FA-Y-0012

**Notice of withdrawal of UL standard certification for MELSEC-Q Series
Energy Measuring Module and Insulation Monitoring Module**
■Date of Issue

June 2026

Example : Model QE81WH

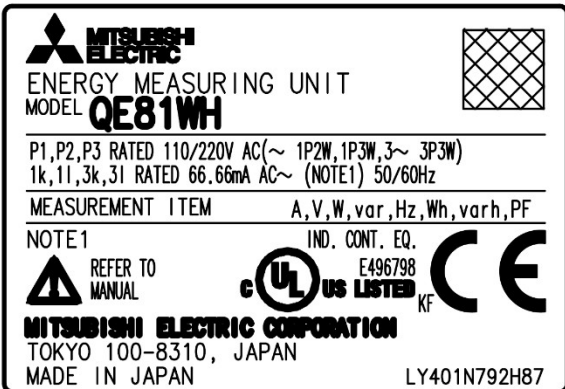
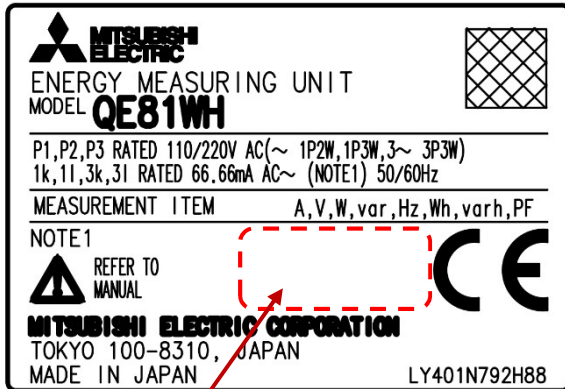
Due to the withdrawal of UL standard certification, the UL mark displayed on the nameplate will be removed as shown below. Please note that there are no changes to the product's general specifications, performance specifications, functions, external dimensions, etc. due to this change.

Before	After
 <p> MITSUBISHI ELECTRIC ENERGY MEASURING UNIT MODEL QE81WH P1,P2,P3 RATED 110/220V AC(~ 1P2W,1P3W,3~ 3P3W) 1k,1l,3k,3l RATED 66.66mA AC~ (NOTE1) 50/60Hz MEASUREMENT ITEM A,V,W,var,Hz,Wh,varh,PF NOTE1 IND. CONT. EQ. REFER TO MANUAL E496798 UL US LISTED KF MITSUBISHI ELECTRIC CORPORATION TOKYO 100-8310, JAPAN MADE IN JAPAN LY401N792H87 </p>	 <p> MITSUBISHI ELECTRIC ENERGY MEASURING UNIT MODEL QE81WH P1,P2,P3 RATED 110/220V AC(~ 1P2W,1P3W,3~ 3P3W) 1k,1l,3k,3l RATED 66.66mA AC~ (NOTE1) 50/60Hz MEASUREMENT ITEM A,V,W,var,Hz,Wh,varh,PF NOTE1 REFER TO MANUAL MITSUBISHI ELECTRIC CORPORATION TOKYO 100-8310, JAPAN MADE IN JAPAN LY401N792H88 </p> <p style="text-align: center;">UL mark removed</p>
